DONALD C. COOK NUCLEAR PLANT UNIT NO. 2

AMENDMENT TO FACILITY OPERATING LICENSE

Amendment No. 64  
License No. DPR-74

Attachment:  
Changes to the Technical  
Specifications

FIGURE 3.2-4 RCS TOTAL FLOWRATE VERSUS R - FOUR LOOPS IN OPERATION

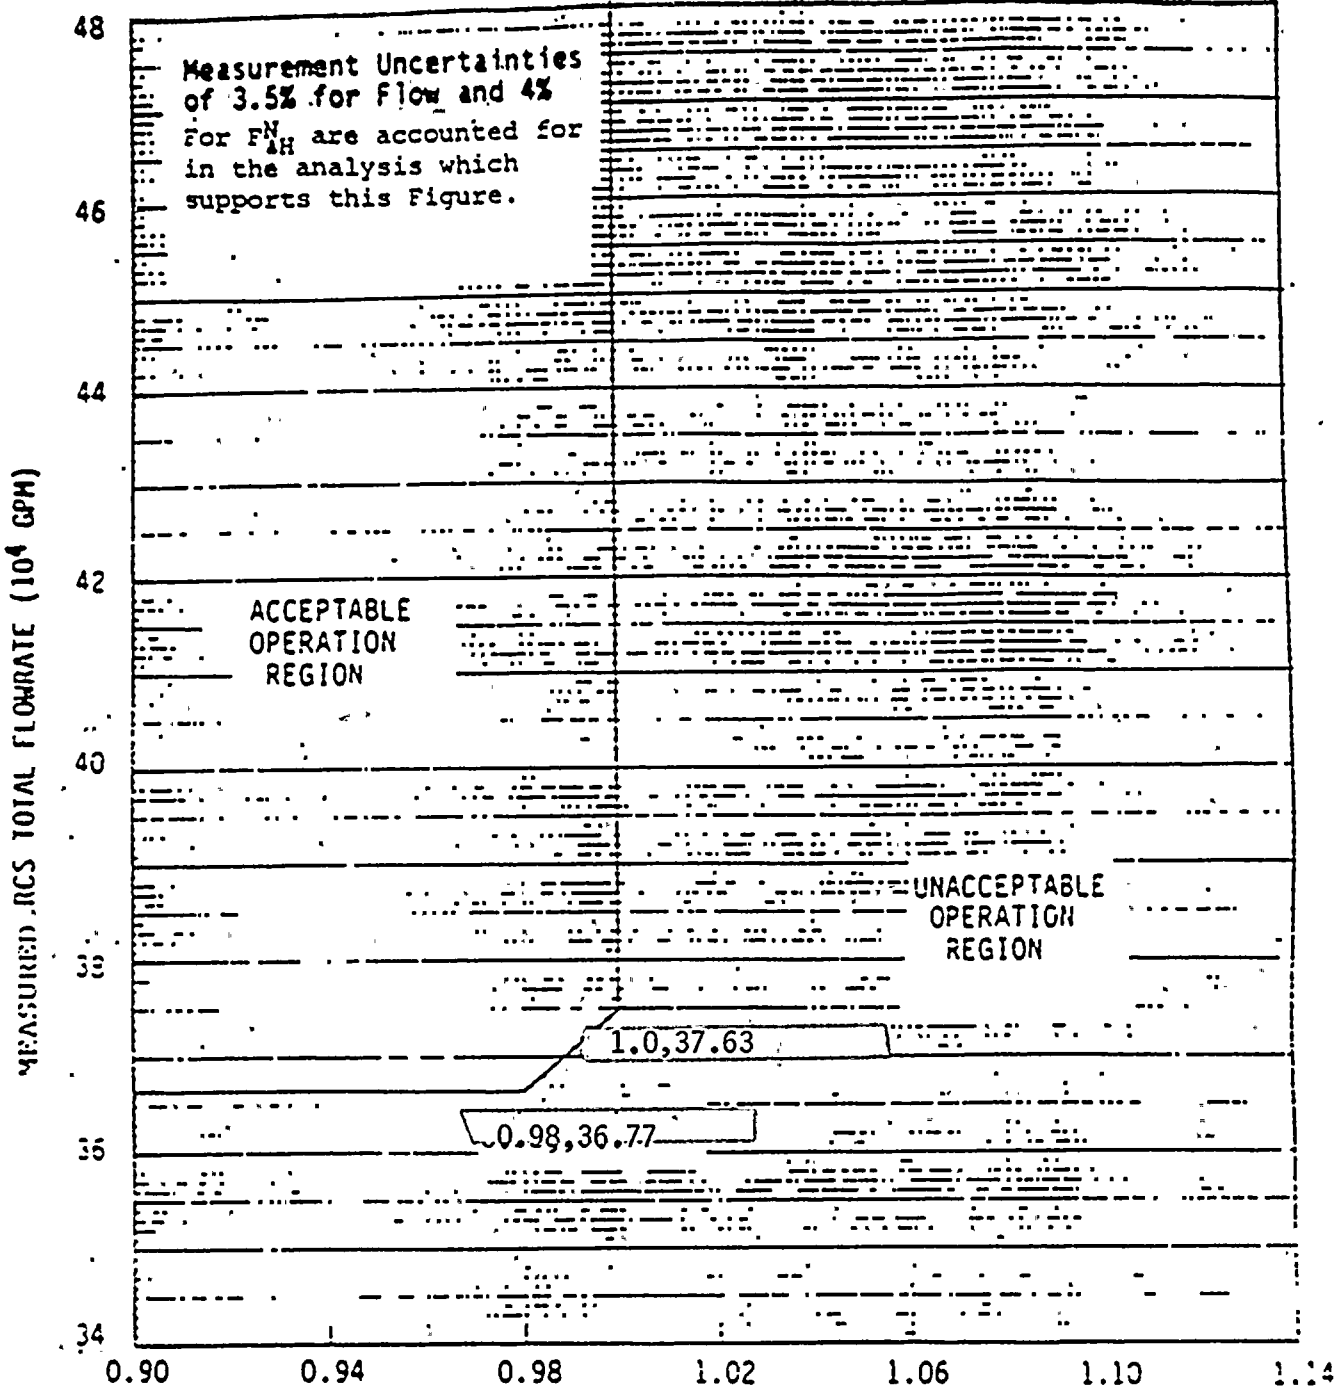
3.2.3 The combination of indicated Reactor Coolant System (RCS) total flow rate and R shall be maintained within the region of allowable operation shown on Figures 3.2-4 and 3.2-5 for 4 and 3 loop operation, respectively.

4.2.3.2  $F_{\Delta H}^N$  shall be determined to be within the above limits and the combination of indicated RCS total flow rate and R shall be determined to be within the region of acceptable operation of Figure 3.2-4 or 3.2-5 (as applicable):

$$R = F_{\Delta H}^N / 1.48 [1.0 + 0.2(1.0 - P)] \text{ WESTINGHOUSE FUEL}$$

$$R = F_{\Delta H}^N / 1.49 [1.0 + 0.2(1.0 - P)] \text{ EXXON NUCLEAR CO. FUEL}$$

FIGURE B 3/4 2-2 ILLUSTRATIVE EXAMPLE OF  $F_{\Delta H}^N$  LIMIT VERSUS PERCENT THERMAL POWER FOR EXXON FUEL

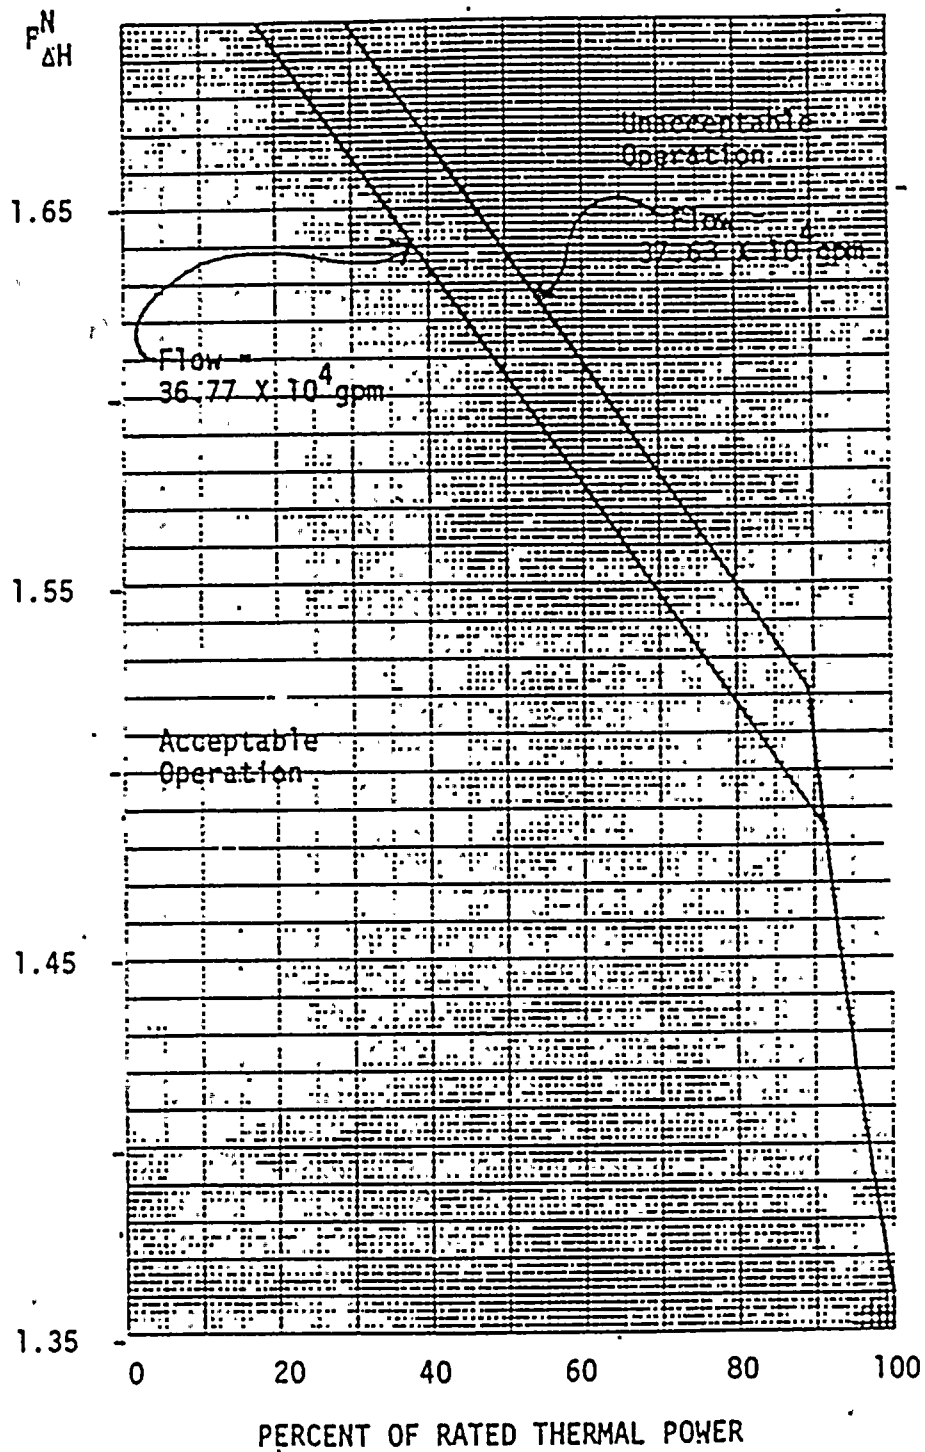
Figure B 3/4 2-2 illustrates the implementation of the limits as a function of power. A measured flow will result in a limiting value for R which must be obtained from Figure 3.2-4 or Figure 3.2-5. From this limiting R, a limiting  $F_{\Delta H}^N$  can be obtained because:

Figure B 3/4 2-2 displays two limiting DNBR  $F_{\Delta H}^N$  curves for Exxon Nuclear Company fuel for flows of  $36.77 \times 10^4$  gpm, and  $37.63 \times 10^4$  gpm. Also displayed on Figure B 3/4 2-2 is the limit on  $F_{\Delta H}^N$  which results from the LOCA analysis for Exxon Nuclear Company fuel.  $F_{\Delta H}^N$  must be maintained below and to the left of both the applicable DNBR  $F_{\Delta H}^N$  limit and the LOCA  $F_{\Delta H}^N$  limit.
